From: Michael Bradbury, Issuing Officer Iowa Department of Administrative Services-Central Procurement Phone 515-823-9327: e-mail: construction.procurement@iowa.gov RE: Addendum No. 2, to Design RFP946200-01, DOE ISD Powerhouse Parking Lot Repair

RFP Number	RFP946200-01	Title of RFP	DOE ISD Powerhouse Parking Lot Repair
---------------	--------------	-----------------	---------------------------------------

1) Google Earth image of ISD Powerhouse Parking Lot

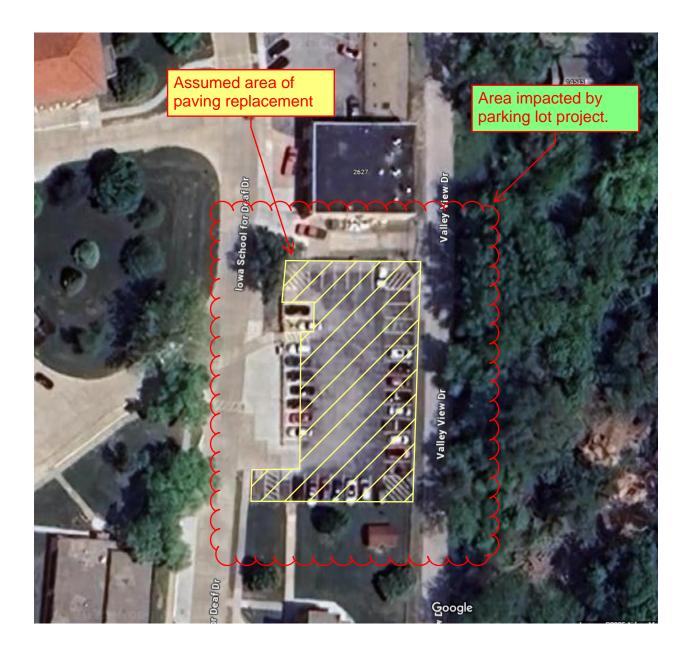
1) For the answer provided on the survey question, can further clarification be given on the actual boundary you are talking about? The ISD property is all 1 property so that would be a full boundary survey. Or would it be just the boundary of the parking lot space? Or would it be just the eastern side of the parking lot space where the parking lota abuts City property? A> Boundary survey will only be required for the immediate area impacting the parking lot. See attached for image of parking lot area. The cost for the Boundary Survey should be listed as a separate line item in the design proposal.
